City of Phoenix
PLANNING AND DEVELOPMENT DEPARTMENT

ADDENDUM A **Staff Report: Z-SP-4-25-2** December 30, 2025

The purpose of this addendum is to revise Stipulation Nos. 1, 5, 6, 7, 25, and 27 to reflect a revised site plan submitted by the applicant and to reflect revised stipulation language agreed upon between staff and the applicant.

SHEET CONTENT:
 Proposed Site Plan

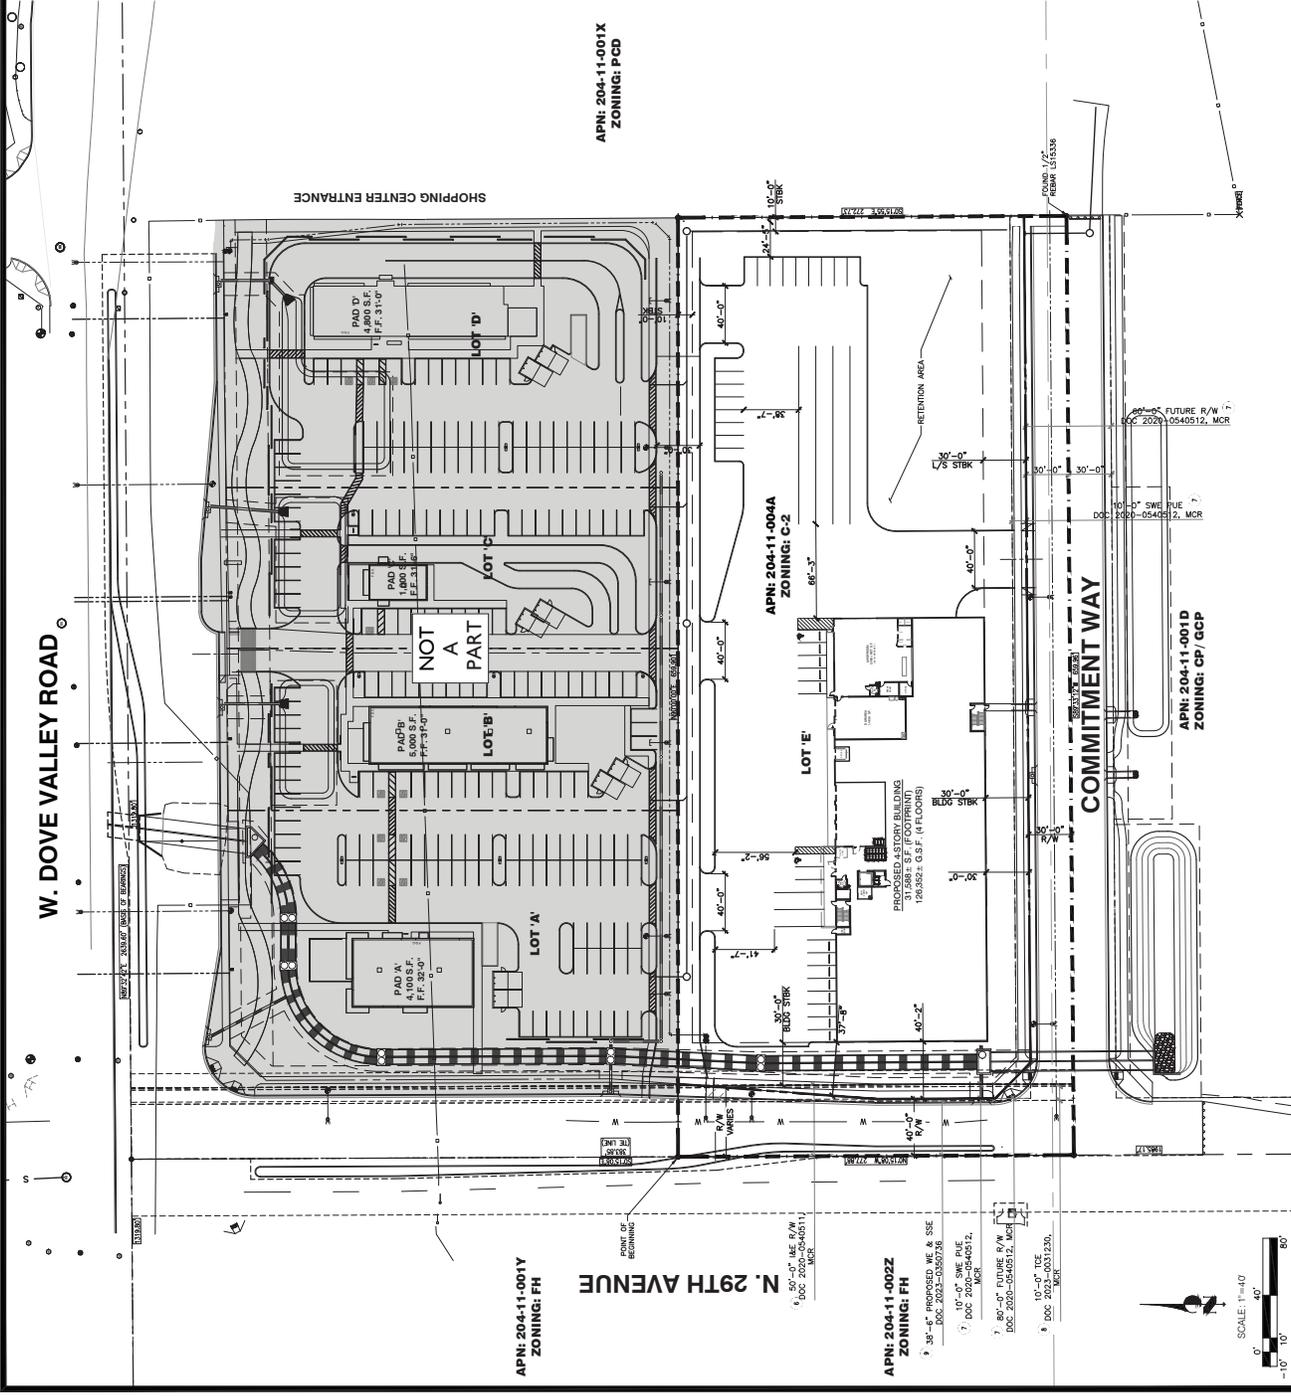
On December 22, 2025, the applicant submitted a revised site plan and a revised landscape plan to include a large surface retention area to act as a landscape screening buffer for the large truck parking areas on the site that may be seen from Woodstock Road (formerly Commitment Way). Staff recommends modifying Stipulation No. 1 to reflect the new submittal date.

Stipulation No. 6 has been revised to consolidate Stipulation 6 and 6.a, to update the setback dimension per the revised site plan, and to remove Stipulation 6.b regarding a wall and mural along 29th Avenue.

Stipulation No. 7.b has been revised to replace the requirement for a wall and mural along Woodstock Road (formerly Commitment Way) with enhanced landscaping within the retention area adjacent to Woodstock Road, in order to screen the large truck parking areas on-site.

Stipulation No. 25 has been revised to only require a detached sidewalk along one driveway on the north side of the site.

1. The development shall be in general conformance with the site plan **DATE STAMPED DECEMBER 22, 2025**, and elevations date stamped November 20, 2025, as modified by the following stipulations, and as approved by the Planning and Development Department.
2. The maximum building height shall be four stories and 56 feet.
3. Colors shall be muted and blend, rather than contrast strongly, with the surrounding desert environment, as approved by the Planning and Development Department.
4. All surface retention areas shall be natural and organic in shape, as approved by the Planning and Development Department.

6. ~~The following~~ **A BUILDING** shall be provided **FRONTING** along the frontage adjacent to 29th Avenue **WITH A MINIMUM OF 45% OF THE FRONTAGE PROVIDED AT A MAXIMUM 41-FOOT SETBACK**, as approved by the Planning and Development Department.
 - a. ~~A building shall be provided fronting along 29th Avenue with a minimum of 45% of the building frontage provided at a 40-foot setback from the property line.~~

- b. ~~A minimum 6-foot tall mural installation shall be provided along the remaining Woodstock Road (formerly Commitment Way) frontage, along the required building setback line and articulated back 5 feet for every 50 feet of wall length, compatible with the design of the overall development, the surrounding community, and the surrounding desert context.~~ **A MINIMUM 30-FOOT LANDSCAPE SETBACK SHALL BE PROVIDED ADJACENT TO WOODSTOCK ROAD (FORMERLY COMMITMENT WAY) FOR THE FIRST 215 FEET FROM THE EAST PROPERTY LINE, PLANTED WITH TWO STAGGERED ROWS OF MINIMUM 2-INCH CALIPER, LARGE CANOPY, SHADE TREES, PLANTED 20 FEET ON CENTER, OR IN EQUIVALENT GROUPINGS, AND A MIXTURE OF DROUGHT-TOLERANT SHRUBS, ACCENTS, AND VEGETATIVE**

GROUNDCOVERS, EVENLY DISTRIBUTED THROUGHOUT THE LANDSCAPE AREA TO ACHIEVE A MINIMUM OF 75% LIVE COVERAGE. A BENCH OR SEATING AREA SHALL ALSO BE PROVIDED WITHIN THE LANDSCAPE AREA.

25. A minimum 5-foot-wide detached sidewalk separated by a minimum 5-foot-wide landscape strip located between the back of curb and sidewalk shall be constructed ~~on the north side and the east side of the site, adjacent to the shared driveways~~ **ALONG ONE DRIVEWAY ON THE NORTH SIDE OF THE SITE TO CONNECT TO EXISTING OR FUTURE PEDESTRIAN WALKWAYS**, planted to the following standards, and as approved by the Planning and Development Department.
